## TECHNICAL BULLETIN GROUP 3J – IMPROVED PRODUCTION AMENDMENTS 2

CAMS Online Manual of Motor Sport, Section 7 – Racing, 3<sup>rd</sup> Category – Touring Cars, Group 3J Improved Production Cars.

Diagram 4

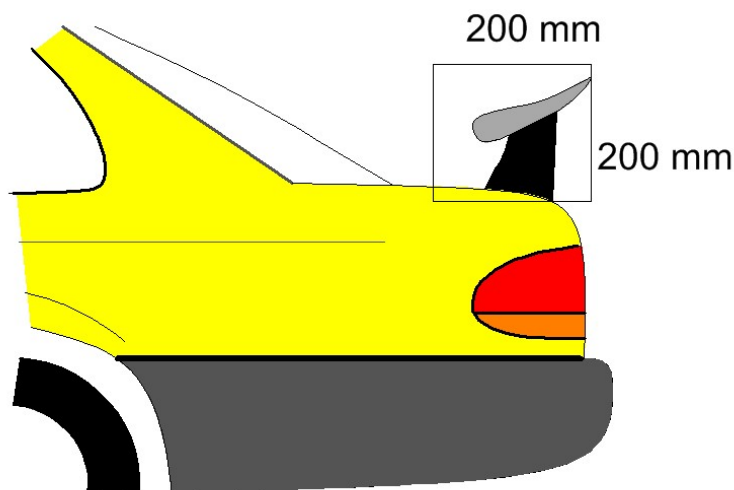
1. To issue amended Diagram 4 reflecting the change in Late Model rear wings
2. To amend the material available for use in wheel flares

1. Replace exiting Diagram 4 with the following Diagram:
